# Service Bulletin

DISHWASHERS

DD 11-02

## Dishwasher Trips Circuit Breaker When Water Valve Is Turned On By Control

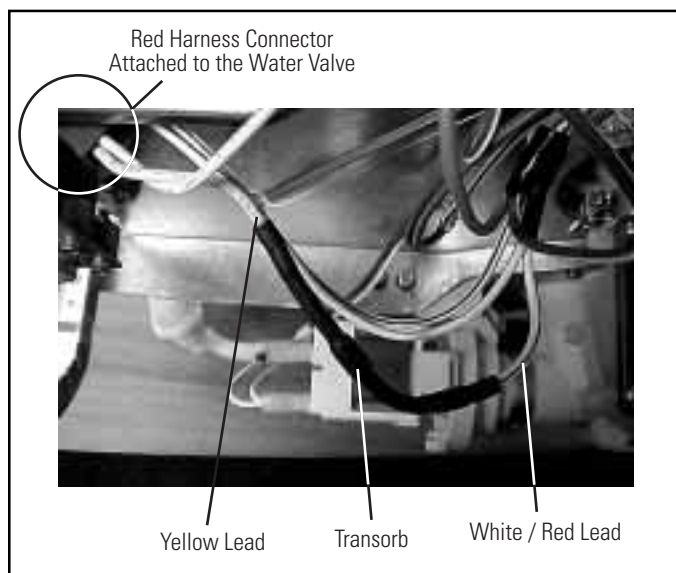
The Triton XL series of dishwashers contain a transient absorber ("**transorb**"). It absorbs electrical transients created when the water valve is turned off. The transorb is wired in the harness between the line and neutral sides of the water valve circuit. It is located approximately 1-1/2 inches from the red water valve harness connector and is attached to a yellow harness lead coming from the water valve on one end and to a white-red neutral wire on the other end. It is covered with black heat shrink tubing. See photo below.

If the transorb fails, it may create a short circuit. This would cause the circuit breaker to trip when the dishwasher control engages the water valve.

Beginning in July 2002, a kit will be available to repair transorbs. The kit number is WD35X10025. It contains a transorb with 2 attached butt connectors and installation instructions.

To install the new transorb, cut the defective part out of the harness and splice in the new one according to the installation instructions. This will eliminate the need to replace the entire harness.

When replacing a transorb, also replace the electronic control, WD21X10117. A shorted transorb may damage the water valve circuit in the electronic control. Replacing the control will eliminate the possibility of a call-back for control problems related to a "shorted" transorb.
